**THE VIEW AT
 CANNON SQUARE
 CHARLOTTE, NORTH CAROLINA**

PROJECT # 06-083
 DATE: MAY 21, 2007
 REVISION: AUG 17, 2007

ARCHITECTURAL
 SITE PLAN
 REZONING PETITION
 2007-104

1 SITE PLAN
 1" = 30'-0"

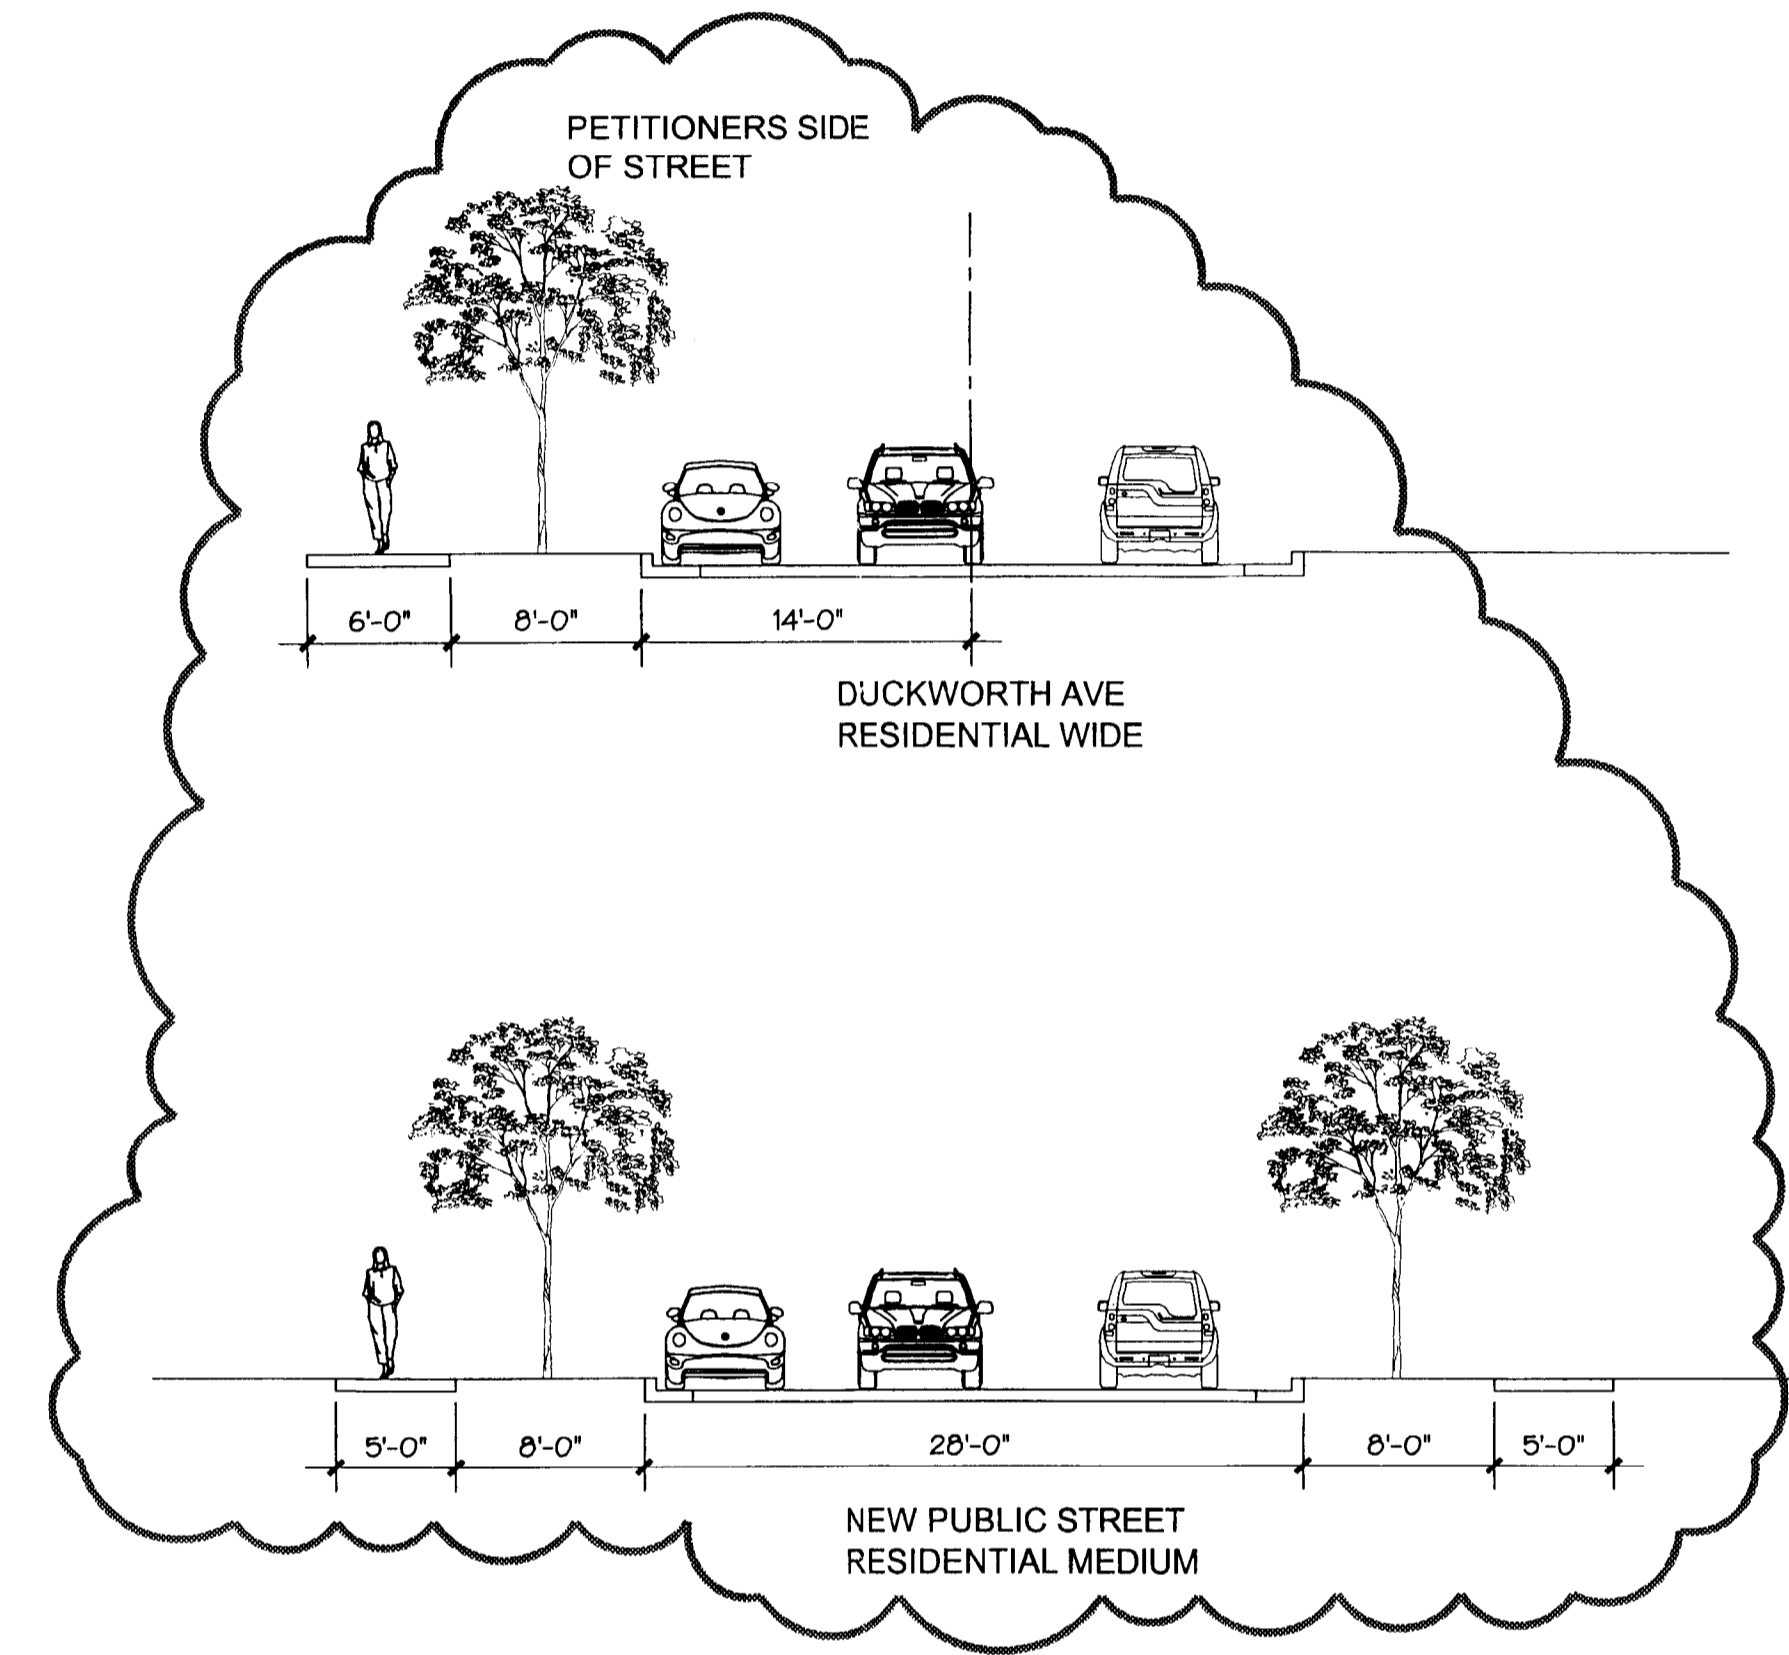
Storm Water Services requests the following notes be added:

Under Note #4 "Storm Water Conditional Notes" add:

"Residential" shall be defined as "A development containing dwelling units with open yards on at least two sides where land is sold with each dwelling unit."

Under "Storm Water Conditional Notes" add:

For commercial projects with greater than 24% BUA, control the peak to match the predevelopment runoff rates for the 10-yr, 6-hr storm and perform a downstream flood analysis to determine whether additional peak control is needed and if so, for what level of storm frequency, or if a downstream analysis is not performed, control the peak for the 10-yr and 25-yr 6-hour storms.

For commercial projects with less than or equal to 24% BUA, but greater than one acre of disturbed area, control the peak to match the predevelopment runoff rates for the 2 and 10-yr, 6-hr storm.

CATS supports CDOT's remarks regarding sidewalks on the petitioner's site:

The UR zoning district requires a minimum of a 6-foot sidewalk. All sidewalks on all public streets within or abutting the site must have a minimum 6-foot sidewalk.

There is a proposed streetcar station located on Trade Street within ¼ mile of this site. In keeping with the TAP and transit station principles, 8-foot planting strips and 8-foot sidewalks need to be constructed along all public streets in/abutting the site, and 8-foot planting strips and 5-foot sidewalks need to be constructed along all private streets.

CATS is requesting the petitioner to construct a waiting pad on Wesley Heights Way, approximately 60' from the proposed driveway access. The waiting pad should be constructed to CATS Development Standards 60.01A

In order to provide adequate customer amenities, CATS is requesting the petitioner to construct a waiting pad, a connecting piece of concrete installed from the back of curb through the planting strip to the sidewalk. This piece of concrete provides an ADA accessible bus stop for CATS' passengers.

Thus, CATS is requesting the petitioner to construct a waiting pad to be constructed to CATS Development Standards 60.01A, to provide customers with an ADA accessible transit stop on Wesley Heights Way.

The UR zoning district requires a minimum of a 6-foot sidewalk. All sidewalks on all public streets within or abutting the site must have a minimum 6-foot sidewalk.

There is a proposed streetcar station located on Trade Street within ¼ mile of this site. In keeping with the TAP and transit station principles, 8-foot planting strips and 8-foot sidewalks need to be constructed along all public streets in/abutting the site, and 8-foot planting strips and 5-foot sidewalks need to be constructed along all private streets.

1. Break up the massing of the multi-family building on Duckworth into two blocks with ped-access to the courtyard.
 2. Indicate the tree save area on the site.
 3. Provide ped-scale lighting throughout the site.
 4. Provide typical cross-section through Duckworth Ave. to illustrate height and finished floor relationships of the multi-family condos and single-family across the street.
- Provide conceptual elevations of: 1 multi-family (facing courtyard) 2. North, South and East elevations of the townhomes. Provide design detail of the courtyard/landscaped area. Provide 8' planting strip and 6' sidewalk along Wesley Heights Way and Duckworth Avenue with large maturing street trees planted between curb and sidewalk. Connect the internal sidewalk network to external sidewalks on Duckworth and Wesley Heights Way. Show dumpster locations on site.
